Docket Item # 2 & 3
BAR CASE # 2015-0002 &
2015-0004

BAR Meeting
February 4, 2015

ISSUE: Permit to Demolish and Certificate of Appropriateness
for Alterations

LOCATION: 724 South Royal Street

Figure 2: c1940s Yates Gardens Interior Photo of a Bay Window

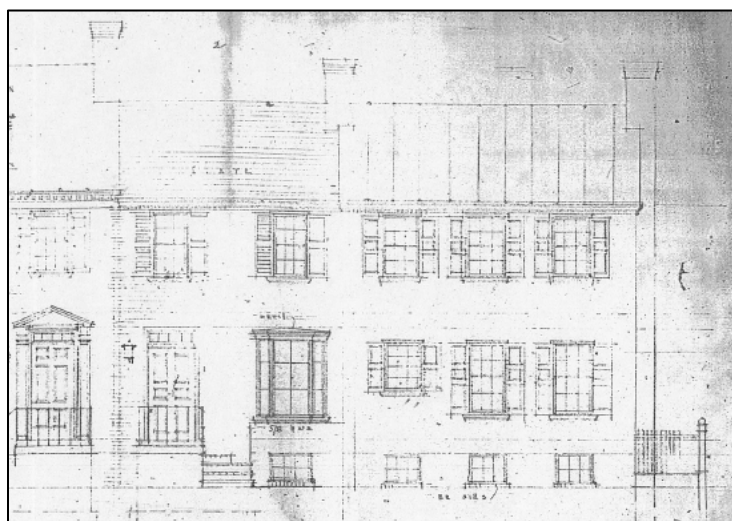
The two-story, brick townhouse at 724 South Royal was built in the Colonial Revival style in the 1940s¹ as part of the Yates Gardens subdivision. It is a mid-block, interior unit in a string of seven attached houses. Based on staff research on the Yates Garden's development, it appears when these buildings were designed and ultimately constructed an array of Colonial Revival details, including bay windows, were part of the subdivision's original features, as shown in the photos and drawings below.

Regarding the proposed alterations to the existing building, staff supports the installation of a new window on the front elevation based on the above photo documentation, which identifies that bay windows of very similar configurations were an original design option provided by the architect for townhouses throughout the development. Staff finds that, since this was a design

PROPOSED
BAY WINDOW

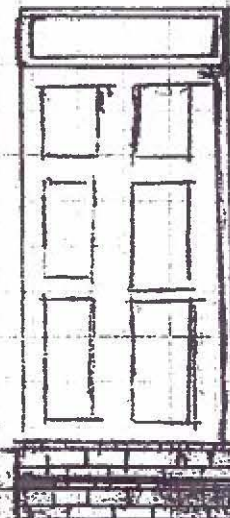
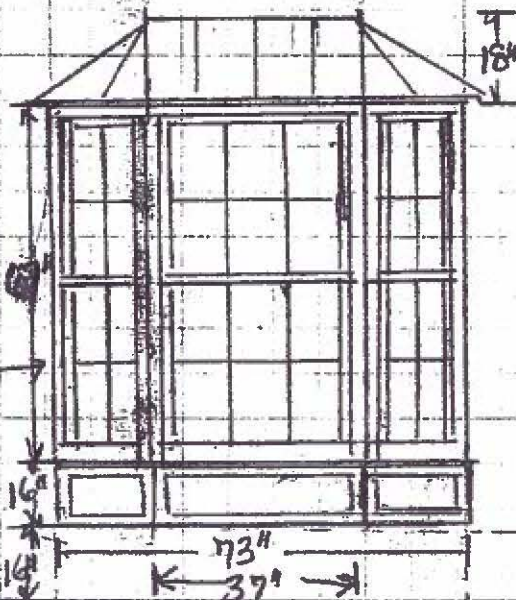
- That the aluminum clad wood windows proposed on the addition are consistent with the *Window Performance Specifications* – including putty profile muntins.
- That BAR approval is subject to compliance with the Zoning Ordinance. Applicant must submit FAR and open space calculations for bay window bump-out for zoning approval prior to the release of Building Permits.

C-1 Zoning compliance cannot be determined. Applicant must submit open space and FAR calculations for bay window bump out.
